Interpretation request for 802.1ah: L2 Gateway Protocol description

Mick Seaman

Figure 1—Port Receive state machine (with needed 802.1ah functionality added)

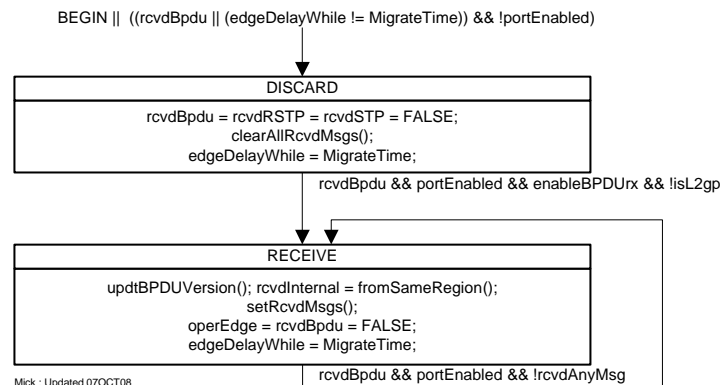
802.1ah makes a change to the Port Information Machine (PIM, 802.1Q Figure 13-14) preventing a transition to the RECEIVE state when `isL2gp` is True. This will defeat the discussed operation of the Port Receive Pseudo Information state machine, which is meant to set `rcvdXstMsg` to prompt this machine to process its regular pseudo messages. It appears that this state machine should have been left unchanged, as in Figure 2, and the Port Receive state machine (PRX) modified instead as in Figure 1. If the latter were not modified the operation of the state machines would be unpredictable as there would be a race between PRX and Port Receive Pseudo Information machine to clear `rcvdBpdu`.

Figure 3—L2 Gateway Port Receive state machine

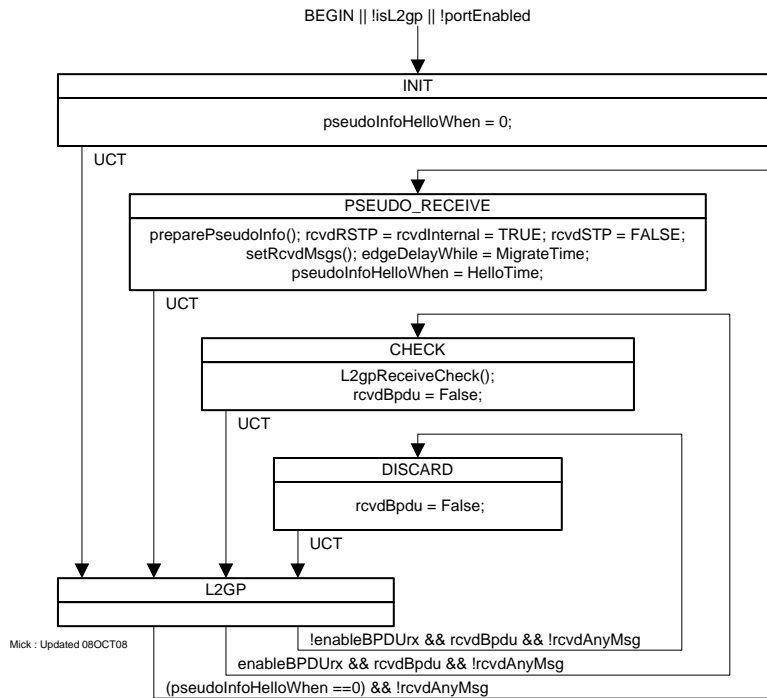
802.1ah’s Port Receive Pseudo Information machine has the following curiosities, which seem neither desired nor reflected in the text of 802.1ah:

- It simulates two BPDU receptions when first enabled.
- It simulates a pseudo-info reception when a BPDU is received even though that BPDU is not used, and its reception will have no effect apart from exercising the other state machines in the system with information they already have. This is true even if `enableBPDUrx` is False.
- It lacks the capability to defend against receive message overrun, which PRX does by its use of `!rcvdAnyMsg`. Without this there could be

unpredictable results if BPDUs arrived faster than the other machine can execute.

- It feeds information to PIM even if the L2GP port is not enabled, therefore preventing use of redundant connections to the backbone, which seems contrary to the general intent.

In addition to the above the Pseudo Information machine got redrawn in P802.1ah D3.5 from a form that was completely consistent with the other state machines to one which largely ignored their diagrammatic conventions. Why I cannot determine.

Figure 3 is a Layer 2 Gateway Protocol state machine (L2GPRX) as a suggested replacement for the Port Receive Pseudo Information machine. Among other things it uses `L2gpReceiveCheck()` as a replacement for the current `checkBPDUconsistency()` procedure.

Figure 4—Changed Port Role Transitions state machine (change from 802.1Q-2006/2008)

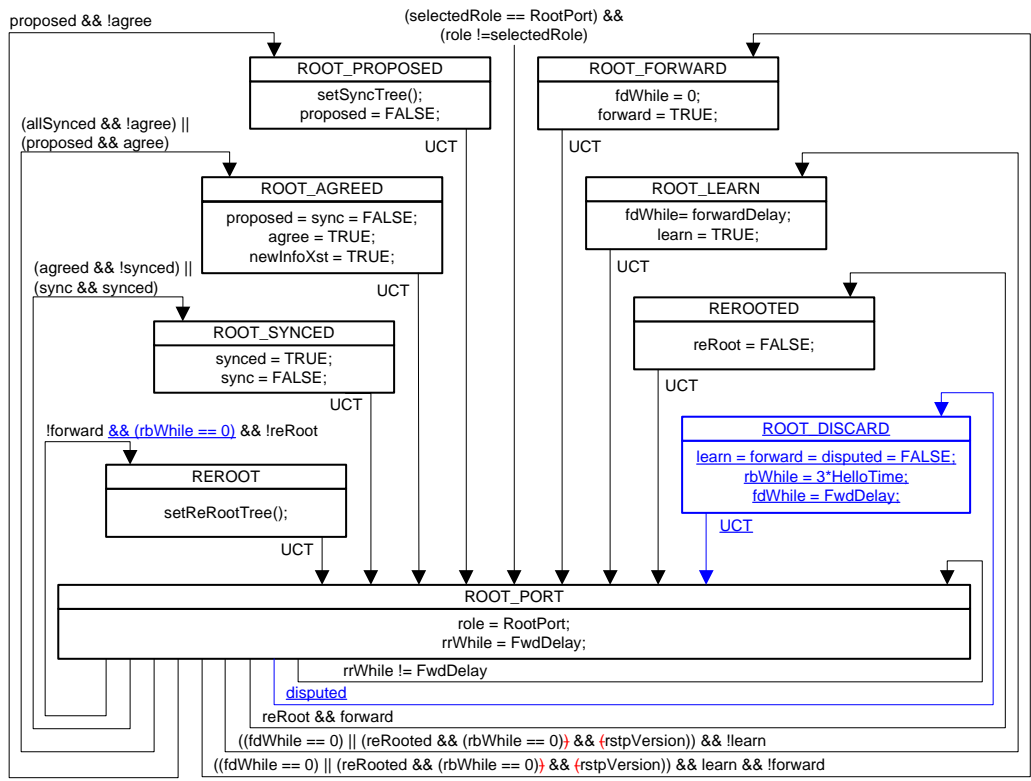
The `checkBPDUconsistency()` procedure currently applies the wrong test. Connectivity should be prevented if the received BPDU contains worse information than pseudo-information. This note provides a replacement procedure (4). The way P802.1ah causes the checking to take effect is through setting the disputed variable, but this variable currently has no effect on a Root Port. Changes so that it has the desired effect are suggested in (5).

Figure 4 is a suggested set of changes to the Root Port states of the Port Role Transition machine (PRT) that cause the port to transition to Discarding if disputed is set, and continues to be set at intervals. I believe that this fixes the identified problem without unwanted side effects, but cannot be absolutely sure.

Figure 5—MSTP state machines overview (updated to show variables L2GPRX uses to signal)

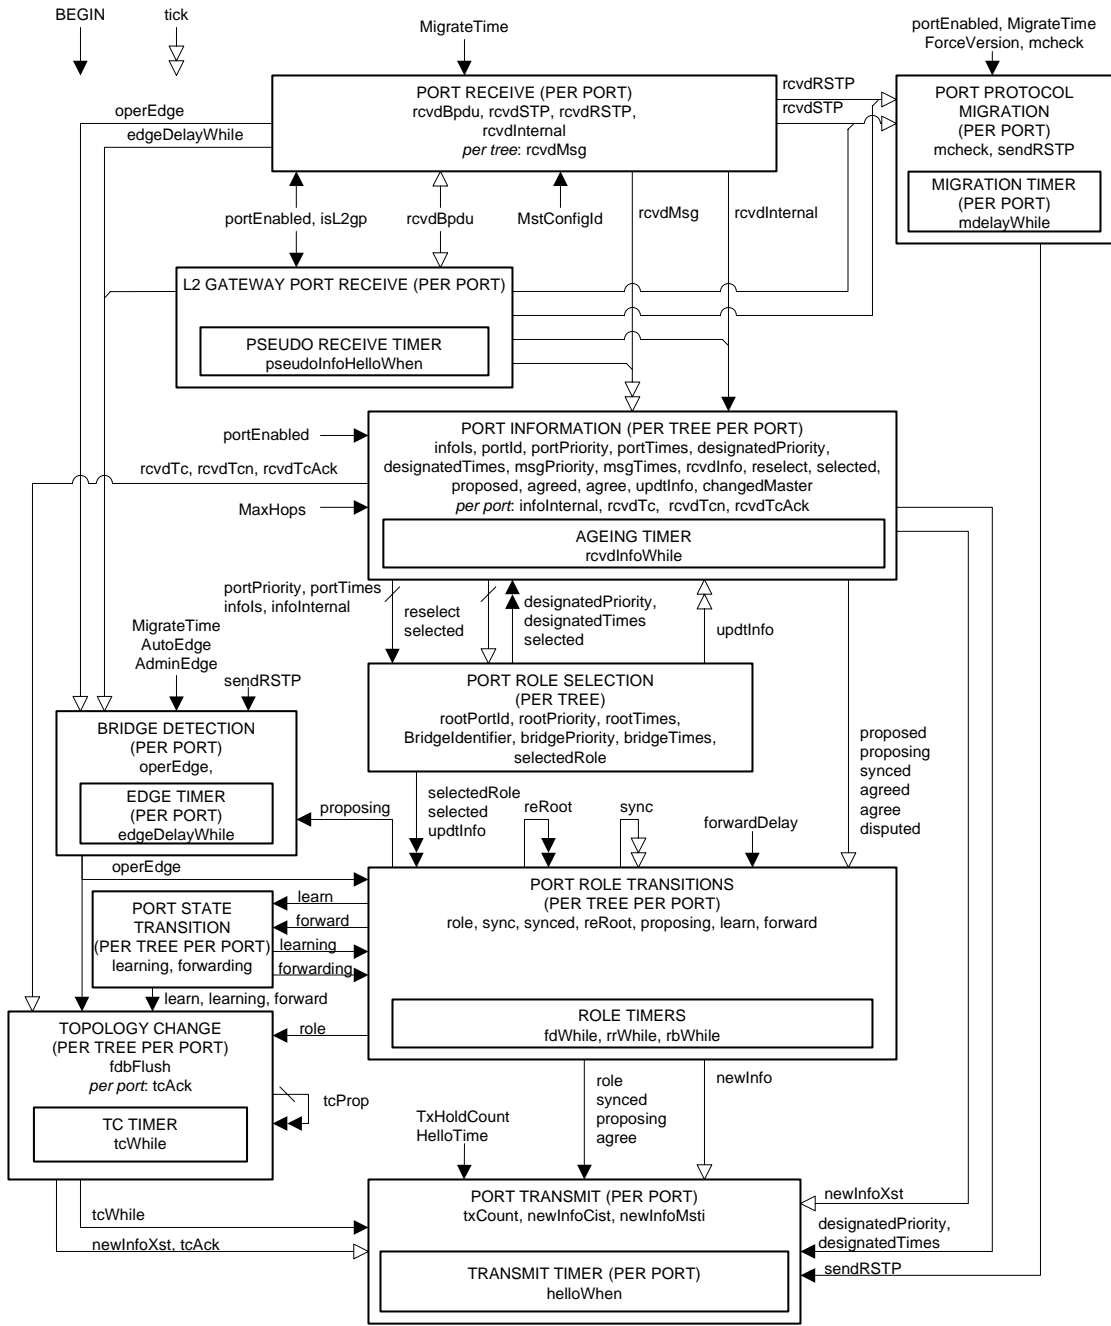
It might have been easier to spot these errors if the state machine overview figure had actually indicated

what variables were being used and affected by the L2GP Port Receive Pseudo Information machine. I have produced an overview figure including my suggested replacement L2GPRX (4).

Figure 5 is a revised state machine overview, i.e. a proposed replacement for 1Q Figure 13-9. It provides information missing from the equivalent figure in 802.1ah.
